RECEIPT DATE: 5/17/23 **ONSITE SEWAGE DISPOSAL SYSTEM**

PROPERTY ADDRESS: 15427 Rivercrest Court

**From:** Freemon, Robert  
**Sent:** Tuesday, March 7, 2023 12:45 PM  
**To:** RTASH@COLUMBIABUILDERSINC.COM  
**Cc:** Paul Cavanaugh; Luke Groom  
**Subject:** 15427 Rivercrest Ct.

### REVISED SEPTIC SYSTEM RIVERCREST

See separate  
sheet for  
As built

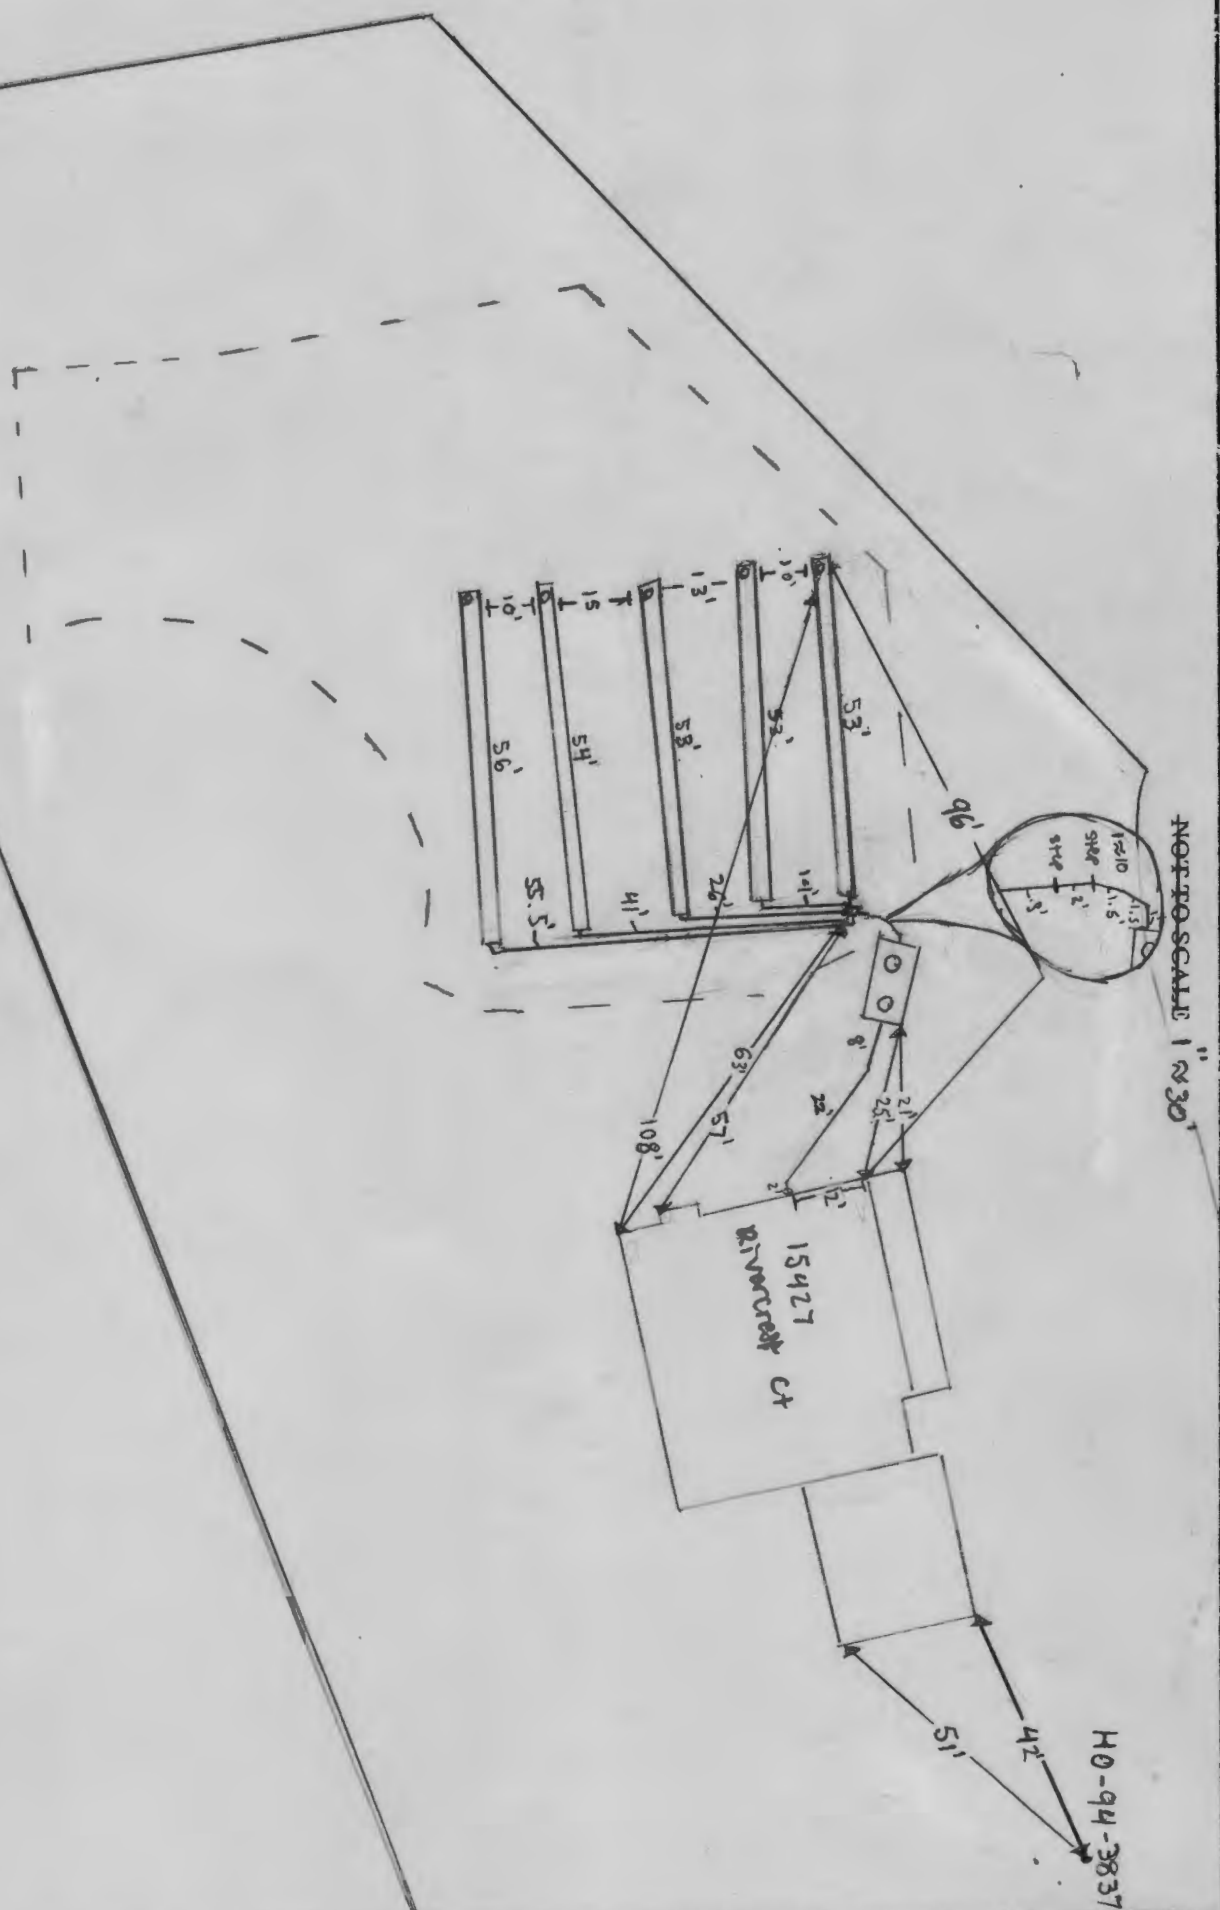
5/26/2023 - 3' of fill on SDA, did not stake trenches. Tank 20' from house & 140' from well. Gave OK to set tank, sewer not stubbed out. Foundation to tank will make fall. (SP)

6/1/2023 - Top 3 trenches measured @ 53', bottom 2 @ 52'. 1, on contour w/ 1"-1.5" difference. Distance between 1, & 1<sub>2</sub> is 14'. 1<sub>2</sub> on contour w/ 1"-1.5" difference. 1<sub>2</sub> & 1<sub>3</sub> is 14' apart. 1<sub>3</sub> on contour w/ 0.5" difference in elevation. Distance between 1<sub>3</sub> & 1<sub>4</sub> is 15'. 1<sub>4</sub> on contour w/ 2" difference. Distance between 1<sub>4</sub> & 1<sub>5</sub> is 13'. 1<sub>5</sub> has 3'-2" difference in contour. (SP)

INSTALLATION: 6/1/2023 - 82w C10 out of house, verified house to tank has fall w/ level. SCH40 90 pipe used. Tank lid depth @ 3'. Saw slots, reinspect for baffles. (SP)

6/2/2023 - 1<sub>5</sub> inlet @ 3.5'-4' length @ 56'. 1<sub>4</sub> @ 54' 1<sub>3</sub> @ 53', 1<sub>2</sub> @ 53'. Saw D-box to 1<sub>3</sub> - 1<sub>5</sub>. Saw 6" front & 4" back baffle in tank. All trenches had the ports. Reinspect for upper trench & level D-box. (SP)

6/5/2023 - 1, inlet 3.5'-4' length @ 53'. Measured 1, to house & D-box to house. 1, stone OK, installer sent pic of fabric, did not have white noise (see attached pic). D-box leveled. Gave OK to backfill all work after fabric installed. (SP)

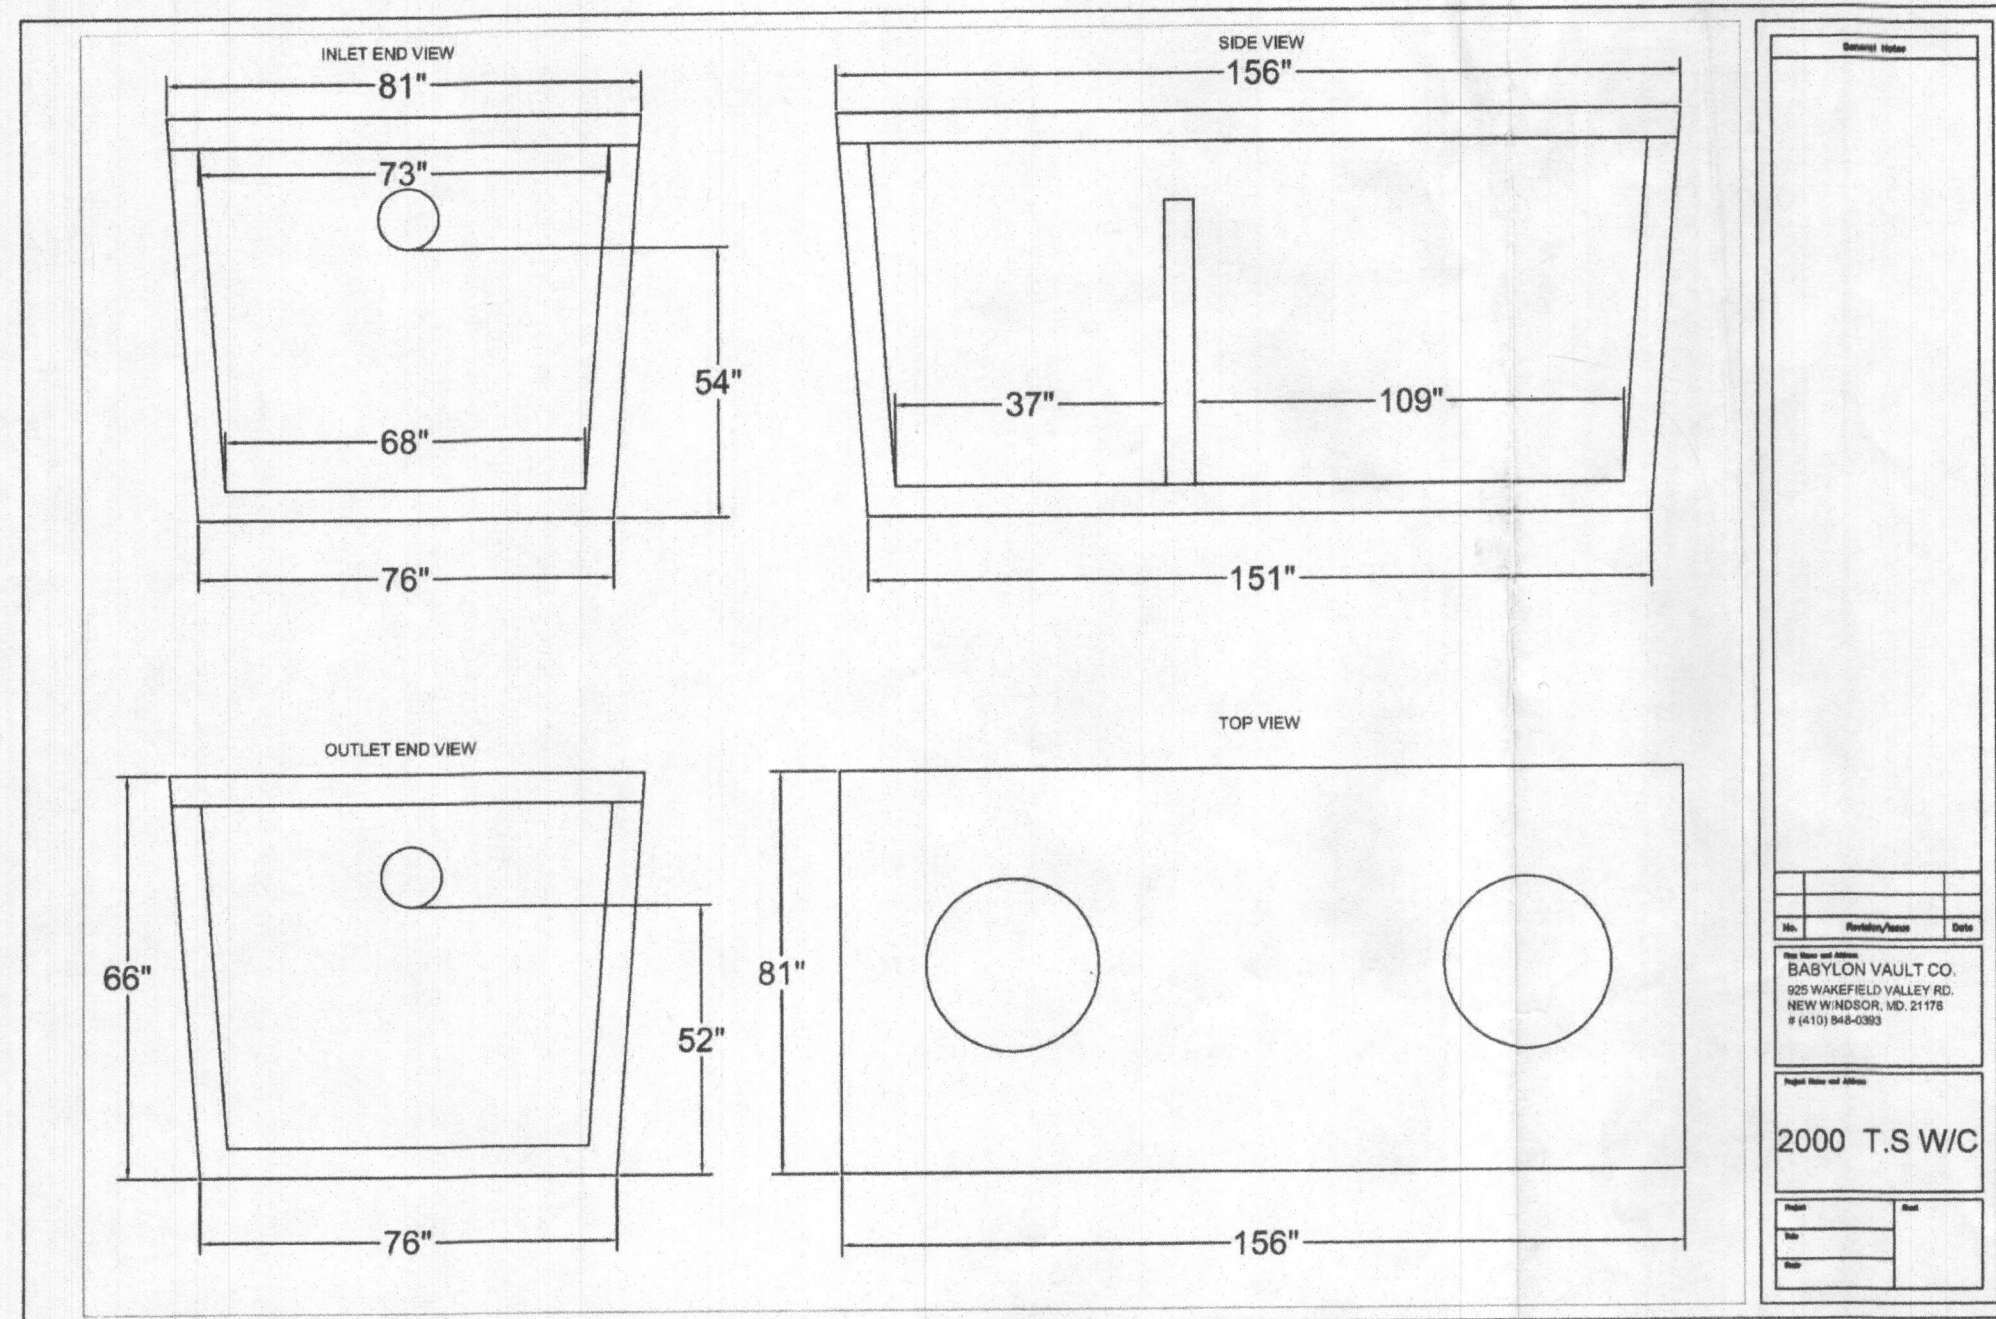
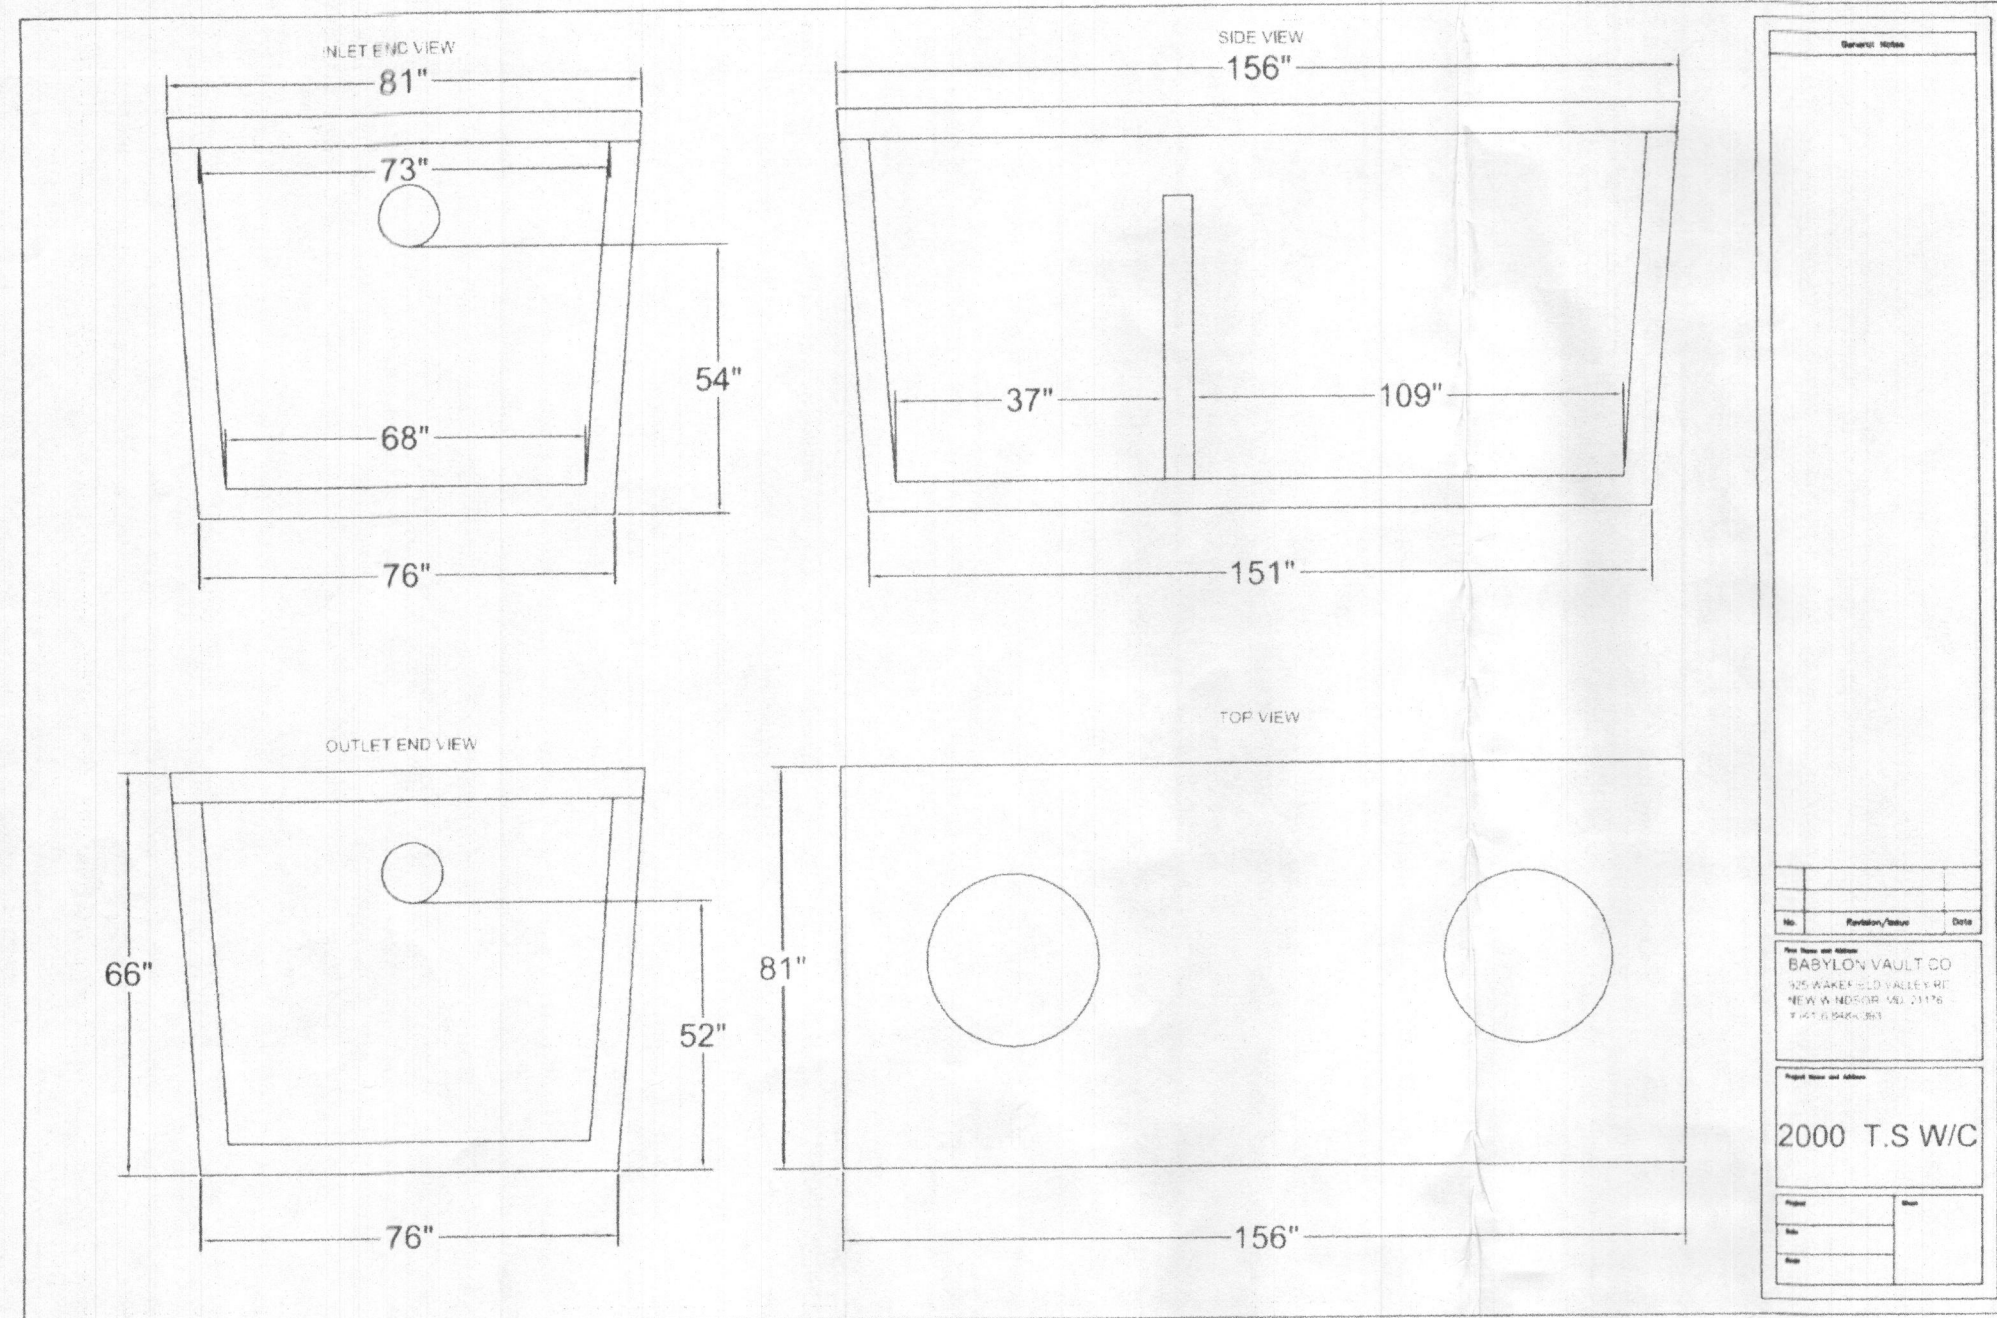
Building permit B23000510 is proposing 5 bedrooms when the OSDS plan was approved for 4 bedrooms. If you want to continue with the current bp proposal the OSDS plan will need to be revised. If you want to keep the approved OSDS plan the floor plans for this building permit will need to be revised. Please let us know which option you are going to move forward with.
